ADDENDUM TO THE STAFF REPORT

BOARD OF ARCHITECTURAL REVIEW FOR TRU BY HILTON; L18-0029

PREPARED AUGUST 14, 2018

Figure 2. Image of the proposed stone tiling on projecting portions of the eastern façade.

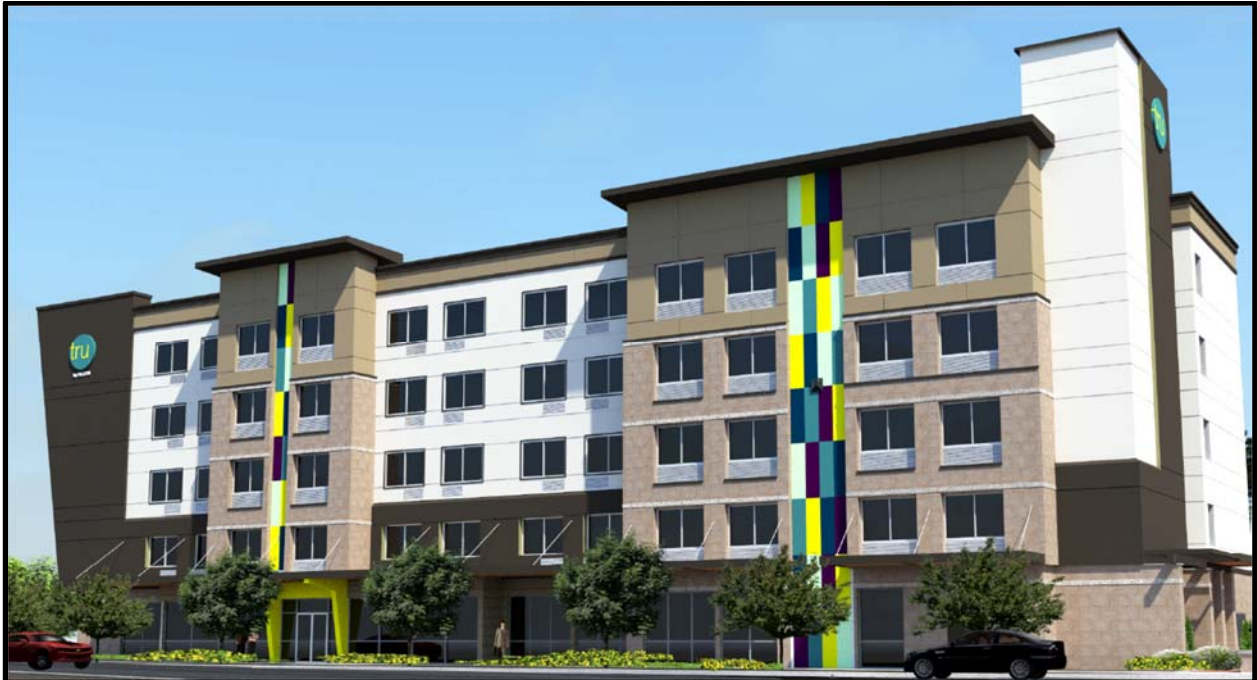
Incorporate an additional building material to visually break up the 95’ of uniform horizontal plane on floors 3-5 on the eastern building façade. Building material shall be consistent with the figures incorporated into the staff report as examples and meet the requirements of the Southcenter Design Guidelines.

The applicant has submitted renderings showing the addition of a new building material to break up the uniform horizontal plane of the eastern building façade and meet recommended condition of approval #2, above. The new material is a light taupe-colored flat stone tile finished with a 6” band of limestone;

The stone is a natural, authentic building material in a warm, rich tone, and it introduces a new color to the hotel's facades. The applicant has rendered western and eastern elevations featuring this new stone material and pattern, shown below in Figures 2 and 3. While the standards of Urban Corridors require a façade articulation increment minimum of 50 ft., the building materials requirements in the Southcenter Design Manual apply to all sides of the building. Building designs should be architecturally consistent or compatible regardless of corridor standards, and so the new stone material is featured on both the western and eastern building facades.

The applicant submitted alternate renderings showing the same building massing as figures 2 and 3 (above), but with the building projections finished in a tan E.I.F.S. material instead of the stone. Staff discussions with the applicant and internally resulted in a strong preference for the natural stone material finishing, and a recommendation to continue the stone treatment all the way up the vertical projections to the rooftop. Recommended condition of approval #1 has been drafted to reflect this suggestion, which the applicant is agreeable to, subject to Board approval.

Both the quality and appearance of the new stone material proposed and its placement in locations emphasizing building and articulation and massing demonstrate consistency with the architectural corridor standards of Urban Corridors and the building materials and colors requirements of the Design Guidelines.

Staff recommends approval of the applicant's revised elevations depicted in Figures 2 and 3 of the addendum to the staff report, with the minor change of extending the stone treatment all the way up to the roofline trim and projections.

Figure 4. The original proposed western roofline had little emphasis on the building's "top".

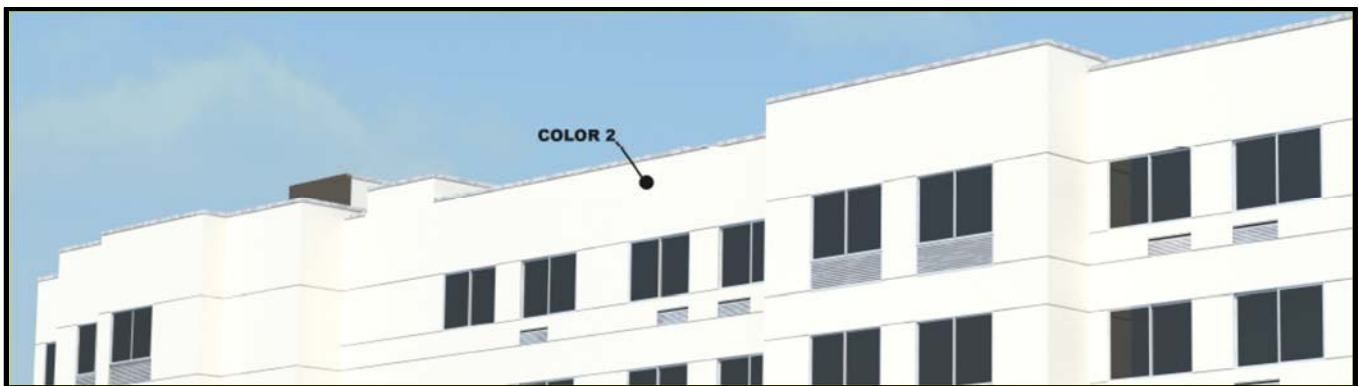
Incorporate one of the recommendations below into a revised building elevation to create a distinct base and top to the hotel:

The original elevations presented at the July hearing (Figure 4, below) showed one section of projecting roofline on the eastern façade and no projections on the western façade, with no molding detail or additional color banding emphasis. The revised elevations depicted in Figures 2 and 3 above and 5 below, show portions of projecting roofline and the overall roofline emphasized in color and finished with a molding trim. The horizontal band of taupe trim emphasizing the roofline is E.F.I.S., bordered by a darker metal trim similar to the material proposed for a small portion of the ground floor building façade treatment.

The renderings and materials submitted after the July hearing reflect the Southcenter Design Manual’s requirements for distinctive, varying roof forms that visually break up building massing and add visual interest.

Staff recommends approval of the applicant’s renderings shown in Figures 2, 3, and 5 as fulfilling condition of approval #5, requiring a distinct building base and top.

Figure 7 (R): Revised elevations showing windows on projections inset several inches and smaller guest room windows finished in contrasting-color E.I.F.S.

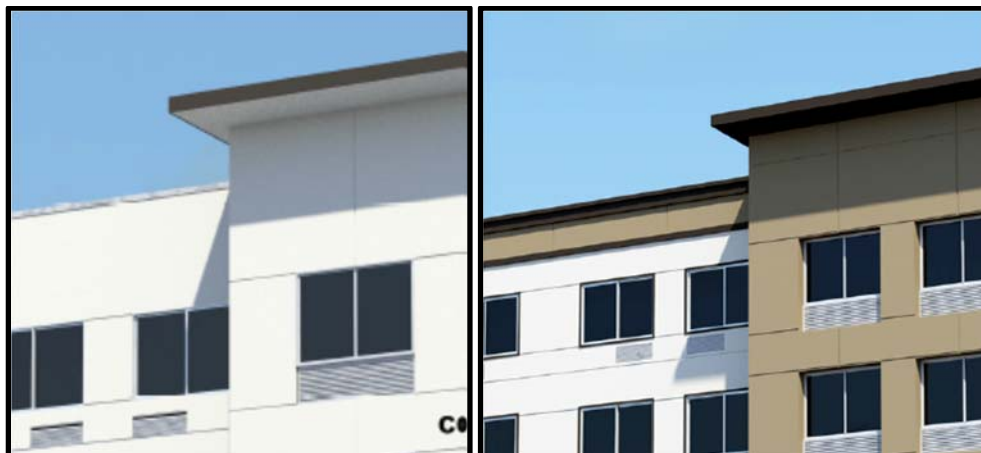
Create a more substantial window appearance by inseting the windows, adding a projecting window sill, or installing a darker-colored window frame or grate.

The elevations shown at the July hearing showed two window shapes- a smaller, squarer window for rooms along the main, flat eastern and western facades and taller, larger, and slightly inset windows for the hotel rooms on the projecting portions of the building. There was no window trim proposed, and there was little ornamental emphasis on windows as part of the overall building design.

Figure 7 above shows added prominence of windows as a design feature. The smaller guest room windows are finished in a contrasting-color E.I.F.S., and windows on the projecting portions of the facades are inset several inches. The contrasting color of trim around the windows and the inseting of some windows meets the Design Manual criteria and fulfills condition of approval #8.

Staff recommends approval of the renderings depicted in Figures 2, 3, and 7 as fulfilling condition #8, requiring increased window prominence.
